**New York State Department of Environmental Conservation
Division of Environmental Permits, Region 4**

Re: Permit #: 4-0103-16/16
373 (HW)/Air Pollution Control Permit Modification
Installing a dedicated burn line for LGF tanks 335-
300, 400, 500 & 600
Cohoes (C), Albany County

The Department has reviewed Norlite's request submitted on April 12, 2005 to install a new dedicated burn line for the hazardous waste storage tanks 335-300, 400, 500 & 600 and hereby approves this permit modification.

RE: *6 NYCRR Part 373 Permit No. 4-0103-16/16-0*
Permit Modification

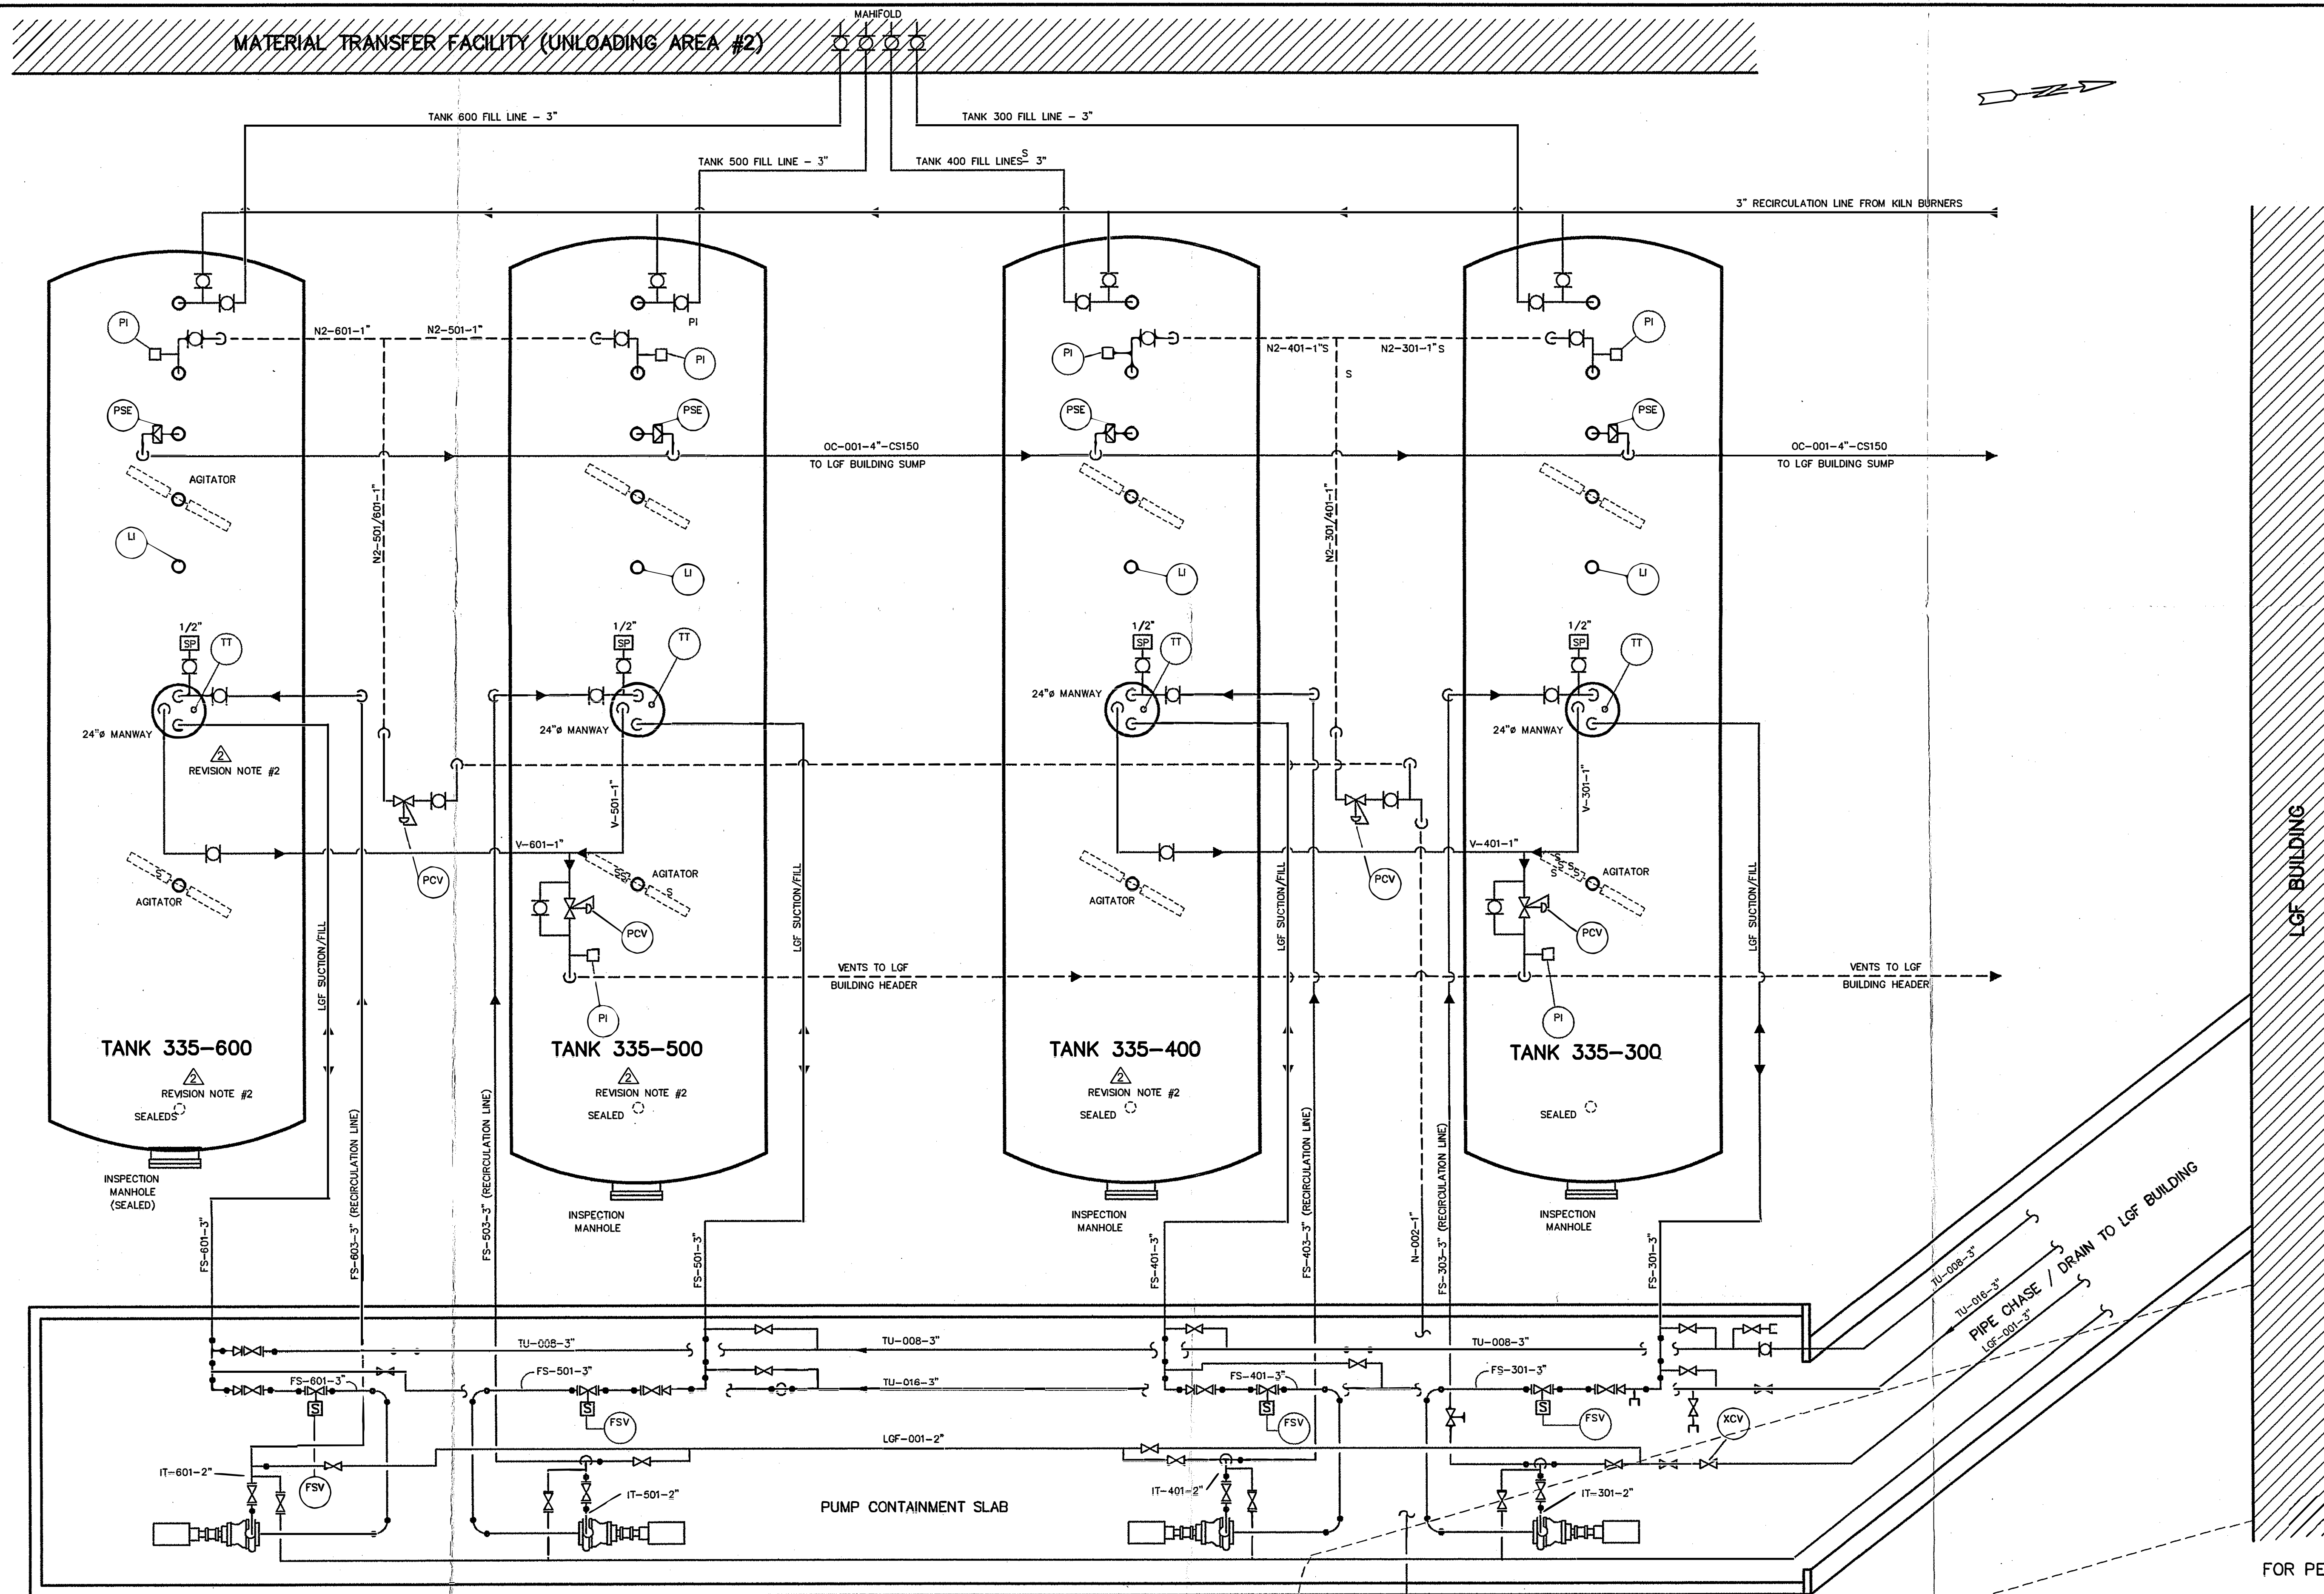
The modification involves installing a new dedicated burn line for the permitted hazardous waste storage tanks 335-300, 335-400, 335-500, and 335-600. Currently, the burn line for these tanks is also utilized as the blend/transfer line. This configuration does not allow Norlite to perform any blending/transferring operations involving the outside tanks while simultaneously burning from an outside tank. The new line will be tied into Norlite's existing LGF burn line #2 within the permitted secondary containment area of the LGF building.

All piping, valves, and flanges will be installed in accordance with 6 NYCRR 373-2.10(d)(6). This modification is shown on the attached drawings: NY003-1312, NY003-1317, and NY003-5432.
